From: Anna Williams
Sent: 9/02/2024 1:21:12 PM
To: Maxwell Duncan; Council Northernbeaches Mailbox
Cc: Paul Mosley
Subject: TRIMMED: Submission objecting to DA 2023/1780 at 89 Marine Parade AVALON.
Attachments: Submission Mosely 89 Marine Parade Avalon.pdf;

RE: DA2023/1780 New Dwelling and swimming pool at 89 Marine Parade Avalon

Figure 2: Extent of Building Envelope breach outlined in red. **Source:** Annabelle Chapman Architect **Annotation:** Blackwattle Planning

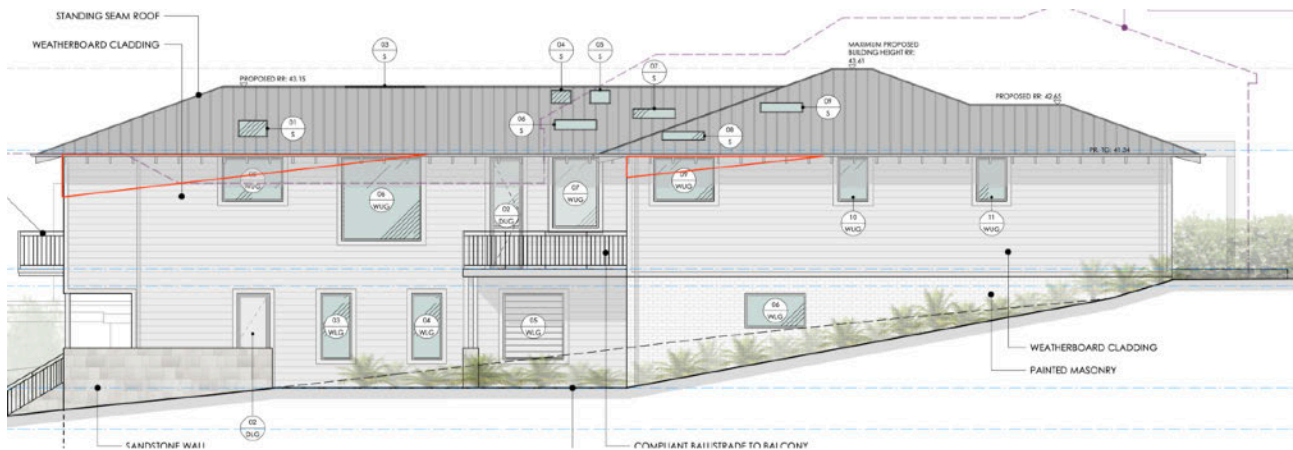
Notwithstanding the inaccurate diagrams, we see that overshadowing impacts will arise upon the private open space areas as a result of non-compliance with the building envelope control. The extent of the building that breaches this requirement is shown outlined in red below:

Impacts that arise from a non-compliance are less reasonable than one that complies. In this case, the variation to the building envelope control is not justified by either exceptions clause in the DCP, ie, the building footprint is not situated on a slope of over 30%, and the proposal is a new dwelling, not a first floor addition to an existing dwelling.

In addition, we note that the extensive excavation of the site proposed negates any construction difficulty posed by the fall of land across the length of the site. Being a site of over 1000sqm and over 18m in width, there is no constraint that justifies the breach of the building envelope control, and therefore the impacts that arise.

A lowering of the floor to ceiling height of the upper floor and therefore the height overall, is both achievable and appropriate and will mitigate this impact.
